Report to Planning and Environment Committee

Subject: Kindred Works (c/o Zelinka Priamo Ltd.)
1901 Jalna Boulevard
City File: Z-9633, Ward 12
Public Participation Meeting

Date: October 23, 2023

Figure 5. Concept Site Plan

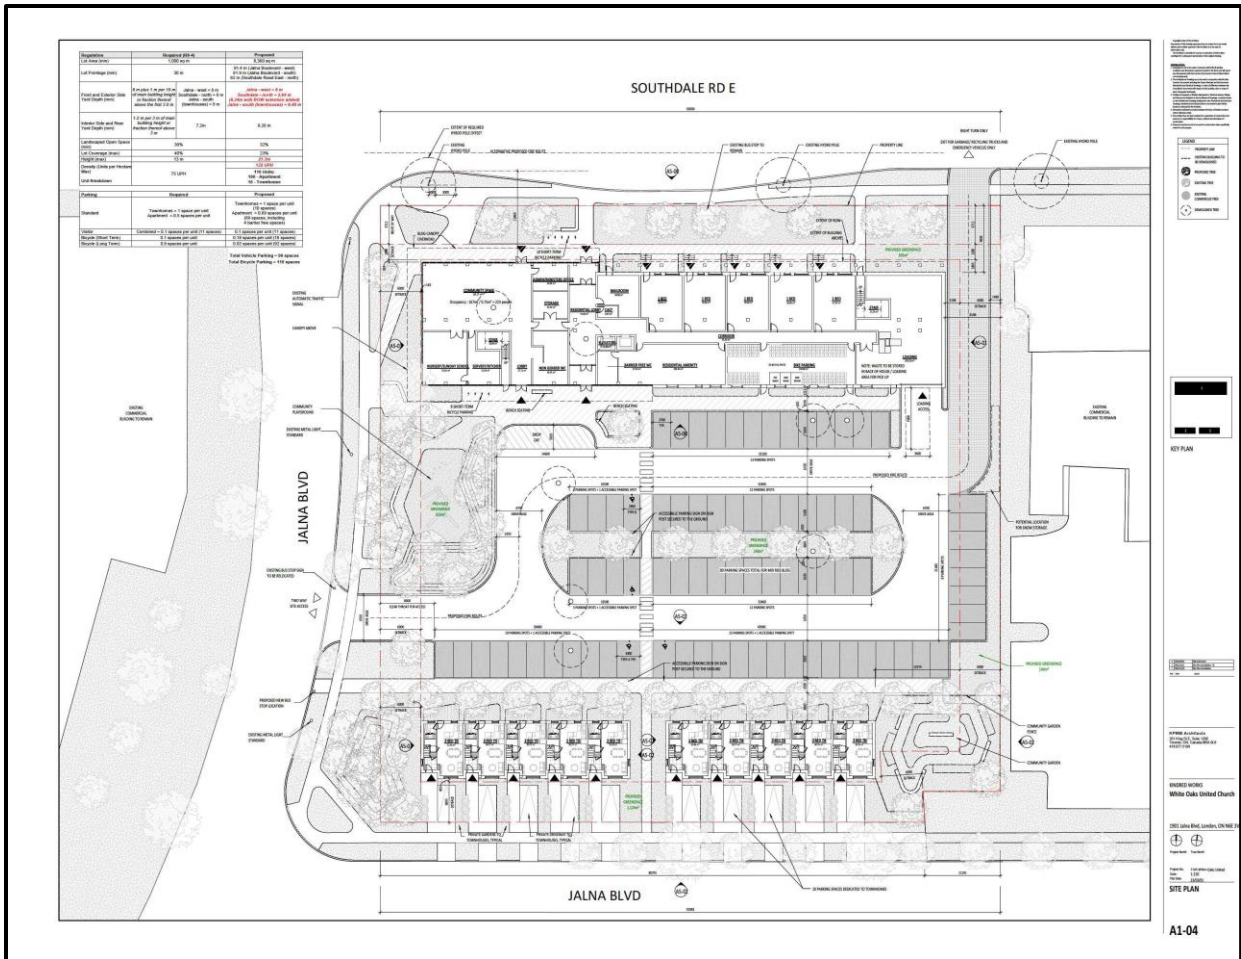
- Concerns raised with the design and location of the right-turn only access along Southdale Road East and Staff have requested its removal and redesign during Site Plan.

- The proposed lay-by was not accessible, and Staff have recommended it be shifted and expanded during Site Plan.
- Accessible parking stalls are to contain a 1.5 metre access aisle.

- The short-term bicycle parking stalls along Southdale Road East are to be relocated to be fully on private property.
- The proposed apartment building should be designed to address its corner location through massing, architectural details, and location of entrances.

Currently the subject site has a single access from Jalna Boulevard South whereby the proposed site layout and parking configuration would facilitate 10 driveways directly onto Jalna Boulevard South with no garages proposed. The proposed increased driveway width, although intended to permit a walkway alongside the driveway, also has the potential to accommodate two vehicles per townhouse unit. As such, the proposed location, configuration, and size of the parking area is not designed to promote connectivity and safety particularly since the driveways are in close proximity to two intersections where site lines are of increased importance with regards to creating traffic hazards (TLP 255_). The parking location is also not sensitive to, compatible with, or fits within the existing and planned neighbourhood context whereby the existing neighbourhood has consistent and observable physical characteristics, including minimal points of access onto the northside of Jalna Boulevard South and driveways leading to garages on the southside of the street (TLP, 953_1). There are also several City trees in the boulevard that would need to be removed to facilitate the driveways.

As such, the applicant's request for a special provision, that *notwithstanding Section 4.19.4 b) parking may be permitted in the south exterior yard along Jalna Boulevard*, is being recommended for refusal as the parking location is not designed to mitigate potential impacts on adjacent and nearby properties, including but not limited to traffic and access management, visual impacts of parking, and pedestrian and cyclist safety (TLP 1578_6). Staff are similarly not in support of the request to increase driveway width to 4.6m.

A preferred alternative design solution that would mitigate the above-noted concerns is to accommodate parking in the rear (north) of the townhouse dwellings, adjacent to the existing proposed parking lot. A reduced setback for the townhouses from Jalna Boulevard would accommodate more room to the north for parking. A secondary solution would be to provide attached garages to minimize the visual impacts of front yard parking. However, this second solution does not necessarily mitigate the safety concerns.

Staff are not supportive of permitting surface parking in the south exterior side yard of the townhouses and are recommending refusal of the requested special provision. As Staff are not supportive of the parking location, the requested special provision for an increased driveway width is also being recommended for refusal.

Concept Site Plan

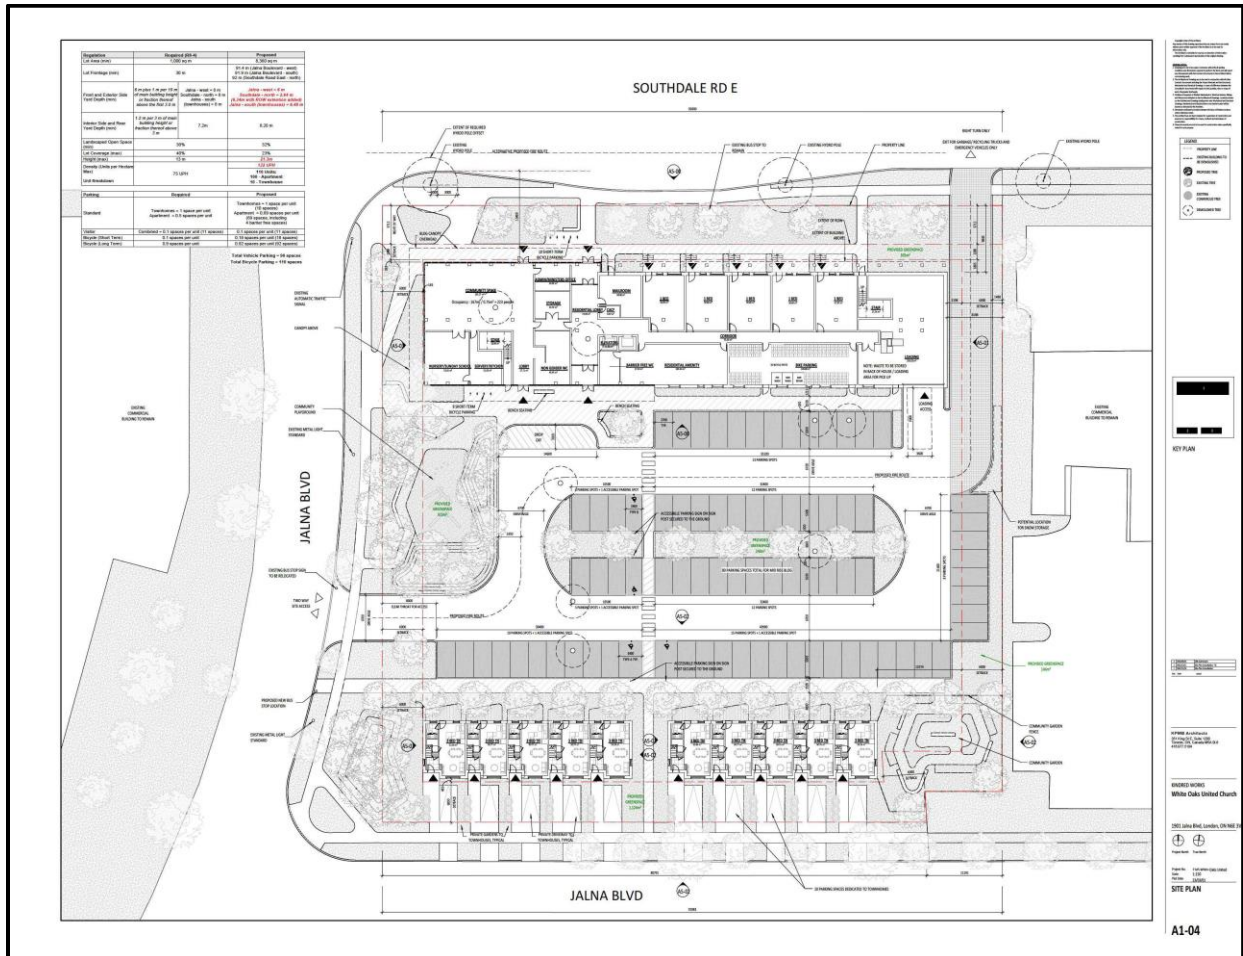
- The driveway widths appear to be wide enough to accommodate more than 1 vehicle (with the sidewalk extension ending at the municipal sidewalk). In accordance with the Zoning By-law Z.-1, Section 4.191, for street-oriented townhouse dwellings in cluster form, the maximum driveway width leading to a parking area shall be no greater than 3 metres for a single car garage and no greater than 6 metres when leading to a two-car garage. A separate regulation applies if these are proposed to be freehold street townhouse dwellings. Applicant is to verify to determine if an additional special provision is required for drive-way widths.

- Accessible parking stalls are to contain a 1.5 metre access aisle.
- Applicant to clarify the intent of the garbage collection. Is there a drop-off area external to the building? Or is the intent for collection vehicles to utilize the loading space?
- The short-term bicycle parking stalls along Southdale Road East are to be relocated to be fully on private property.
- Shift the lay-by slightly to the east to provide a better radius for turning movements.

- There has been significant concern with the design and location of “right turn only exit” access along Southdale Rd. It is anticipated to be misused by traffic residential traffic and therefore we do not support proposed access. It should be removed, and overall site needs to be redesign.
- Proposed lay-by is not accessible, and it is recommended to relocate north side abutting building.
- Access to the Loading and waste collection area needs to be reoriented in absence of Southdale Rd access.

The panel suggests that the proponent review the intention for the future development of the right-of-way along Southdale Road east with City staff. If the large boulevard is to remain and could be planted with trees as shown, the building setback could be appropriate. However, if the city intends to implement road widening, consider the comments below:

The panel notes that it appears a portion of sod along the west edge of the 7-storey building is covered by a canopy. Note that irrigation will need to be provided if soft landscape is to remain as shown. Otherwise, walkways and gardens could be reconfigured to avoid planting areas being covered by the canopy.

The panel recommends further consideration be given to the transition space between the private amenity spaces at the north edge of the townhouses, and the adjacent public walkway and parking spaces. We suggest considering strategies for improving privacy and landscape buffer including a change in grade, hedges, gardens, and/or low transparent fencing with gates.

The project will not remove the parking spaces adjacent to Jalna Blvd as they are essential to the marketability of the apartment units.

The project will not consider consolidating the greenspace to the southwest corner of the site as the site cannot accommodate this change without eliminating one or two townhouses or several parking spaces. The project supports the separate greenspaces as they are each contextually appropriate and sensitive to the scale of their location.
